Essential Clothing Ltd

Akuilchala, Maddhapara, Sakashor, Kailahoir, Gazopur
(24.063310N, 90.314690E)

24th October 2015

Observations

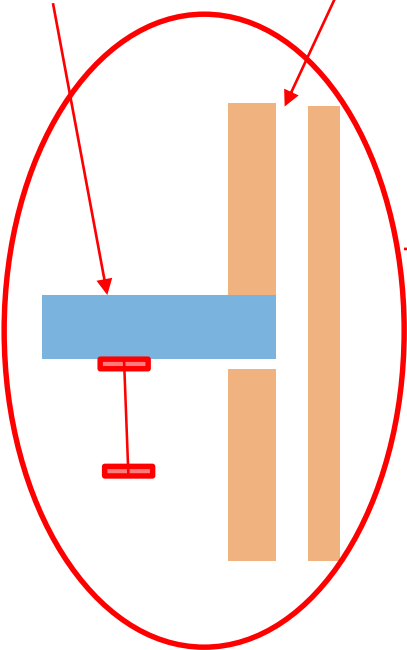
1000 litre water tank is placed directly on slab over toilet

**300/400 mm concrete
build up is found in
toilet areas on first floor**

Item No.	Observation	Recommended Action Plan	Recommended Timeline
9	2000 litre tank on roof slab to toilets	Building Engineer to carry out a review and design calculations to verify that slab and columns have sufficient capacity to support the 2000 litres water tank over the toilets	6-weeks
10	2000 litre tank on roof slab to toilets	Carry out any actions arising from review.	6-months
11	300- 450mm concrete build up in toilet areas on 1st floor	Building Engineer to ensure the 1st floor composite slab is capable of carrying the concrete build –up, walls and roof slab in the toilet area	6-weeks
12	300- 450mm concrete build up in toilet areas on 1st floor	Carry out any remedial actions required	6-months
13	Front elevation: inner leaf of external wall supported of cantilever 1st floor slab	Building Engineer to review by design calculations 1st floor slab capacity to carry the external front wall on the cantilever.	6-weeks
